Re: Proposed Smeaton Grange Waste Recycling and Transfer Facility, 52 Anderson Road, Smeaton Grange (SSD 15_7424)

We have provided responses to the matters raised to assist with finalising the Camden Council's submission on the proposal to the Department of Planning and Environment.

EMM Consulting Pty Limited act on behalf of Benedict Recycling in this matter.

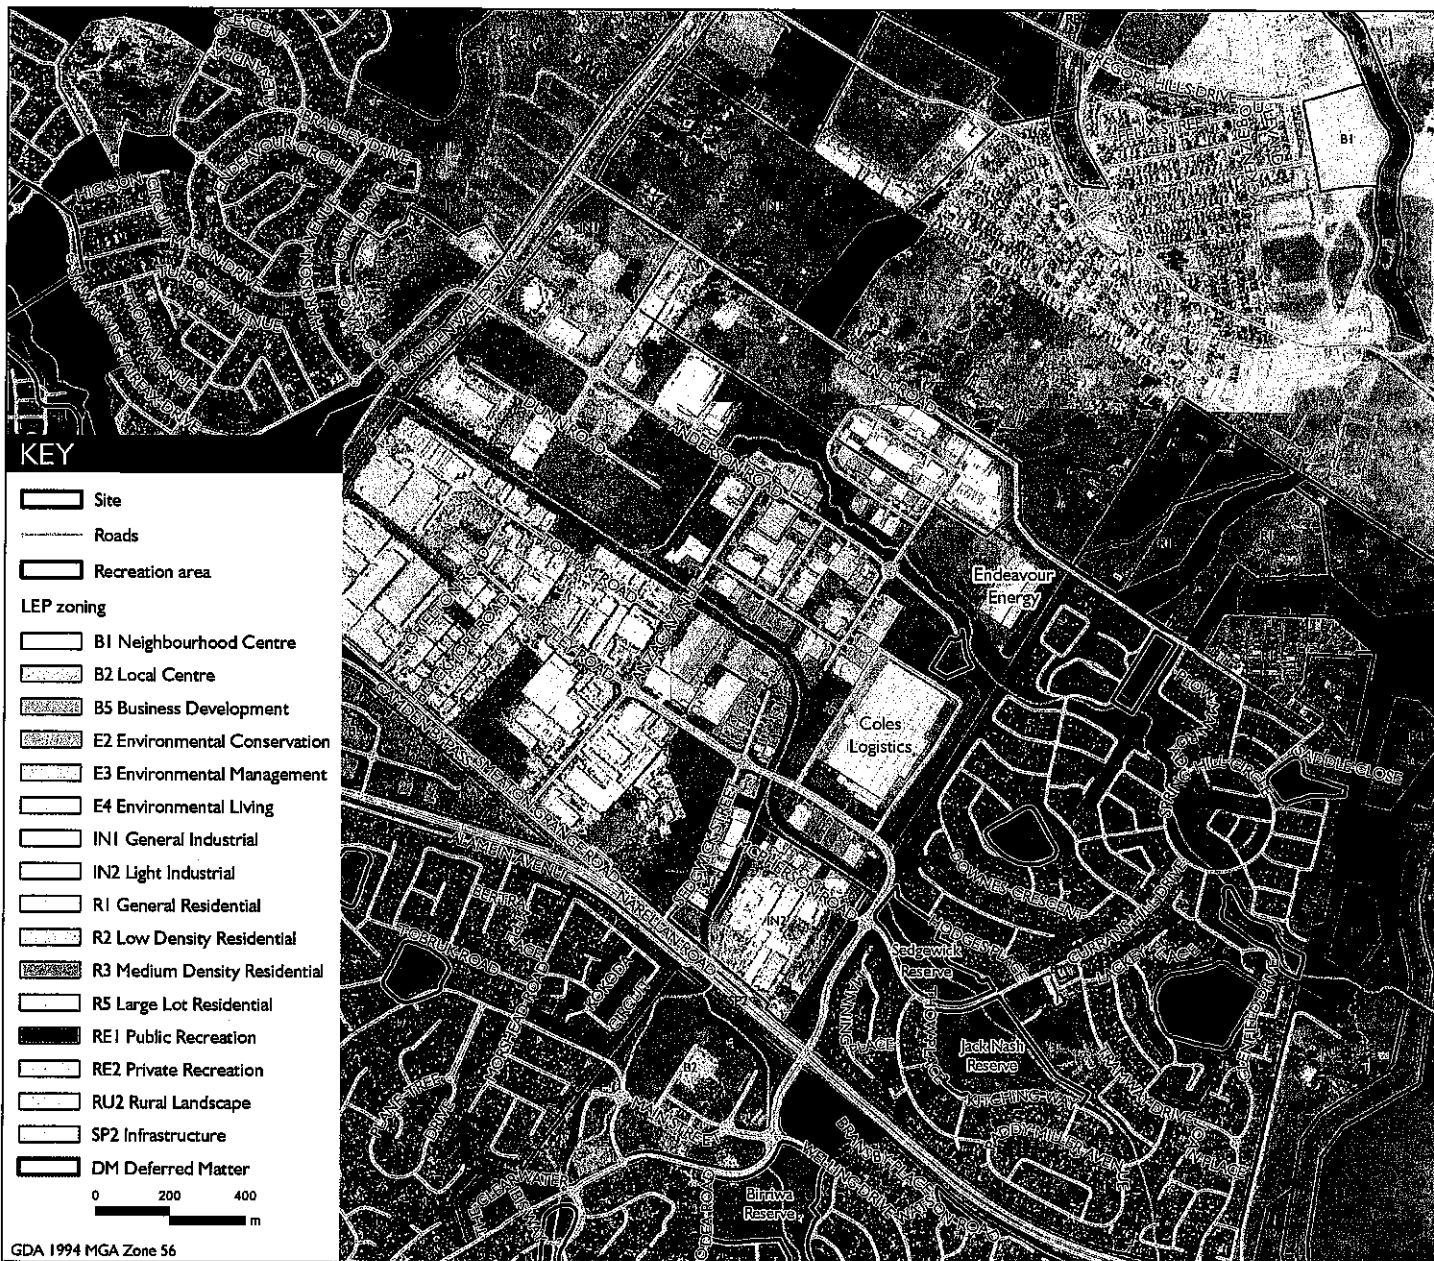
4.14.7 Plans

We are unsure which section of Schedule 1 of the Environmental Planning and Assessment Regulation 2000 lists these requirements.

A site location plan is provided in EIS Figure 1.1, wider views are provided elsewhere in the EIS (including appendices) as appropriate to when considering potential impacts of the project. For example Figure 6.1 shows air quality and noise sensitive receiver locations and Figure 6.2 viewpoints. Both show all of the locations, including residences that are potentially impacted.

A figure showing a wider area is attached to this letter. This shows planning zones as an indication of land uses.

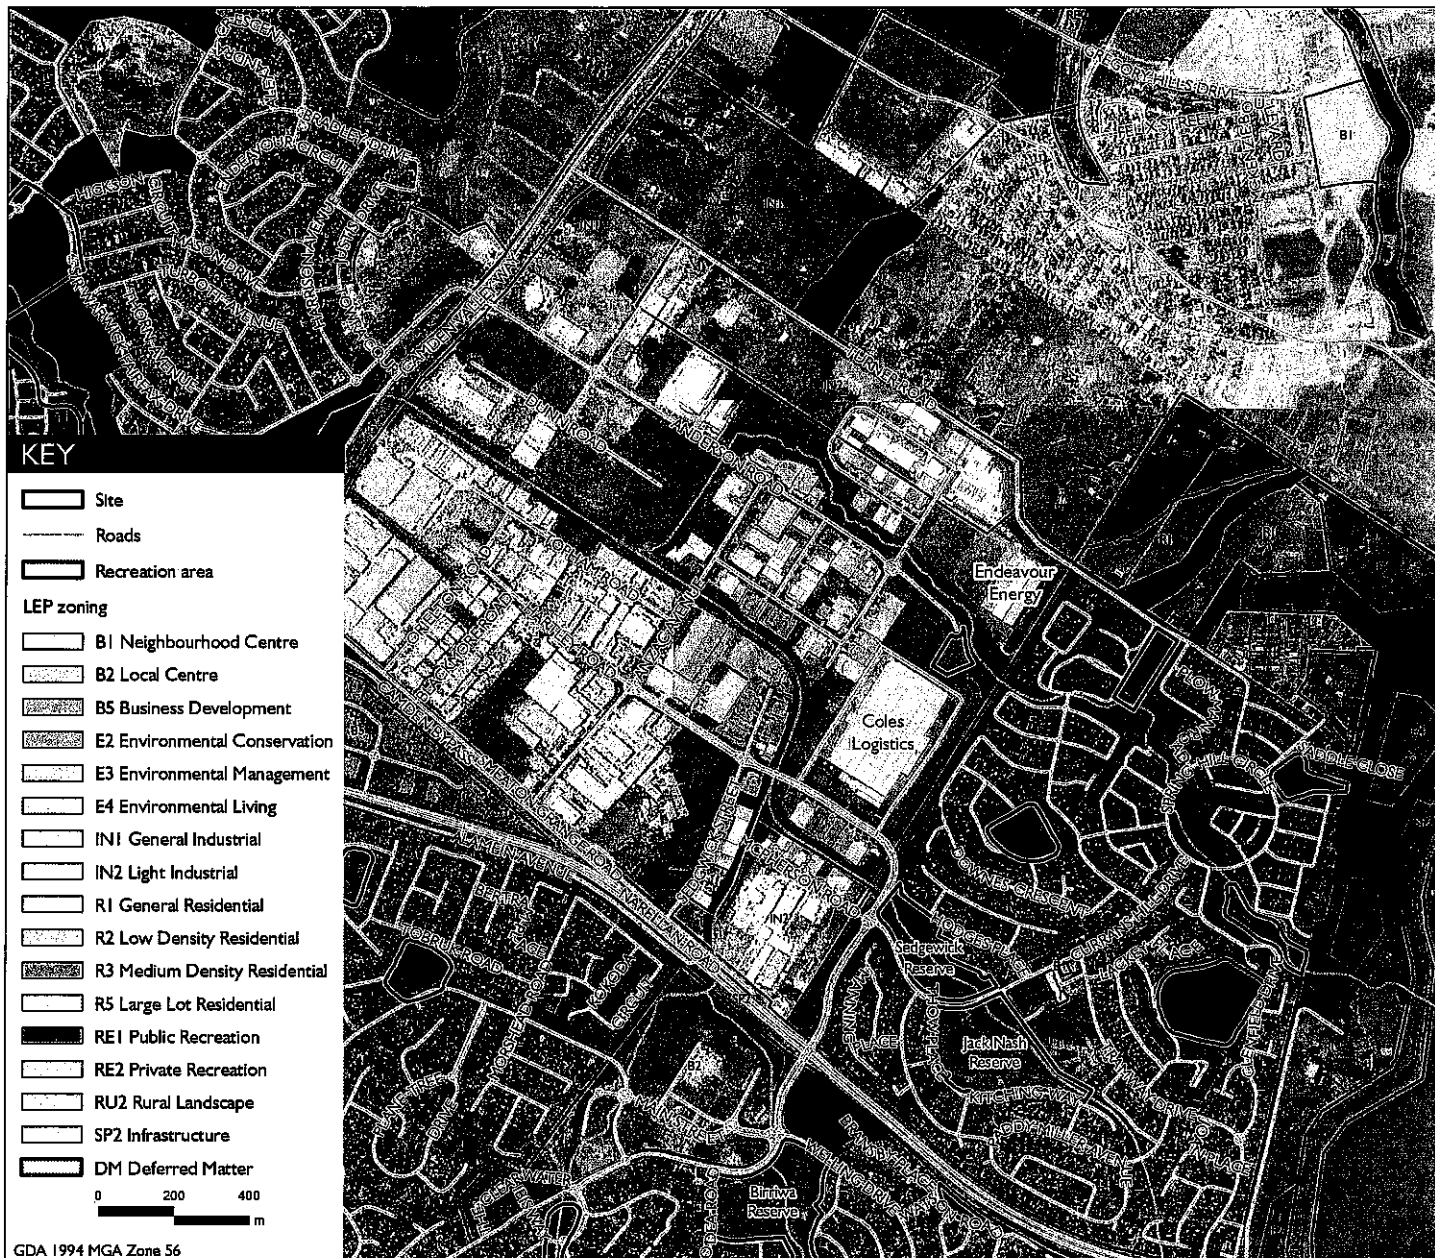
4.14.7 Plans

We are unsure which section of Schedule 1 of the Environmental Planning and Assessment Regulation 2000 lists these requirements.

A site location plan is provided in EIS Figure 1.1, wider views are provided elsewhere in the EIS (including appendices) as appropriate to when considering potential impacts of the project. For example Figure 6.1 shows air quality and noise sensitive receiver locations and Figure 6.2 viewpoints. Both show all of the locations, including residences that are potentially impacted.

A figure showing a wider area is attached to this letter. This shows planning zones as an indication of land uses.
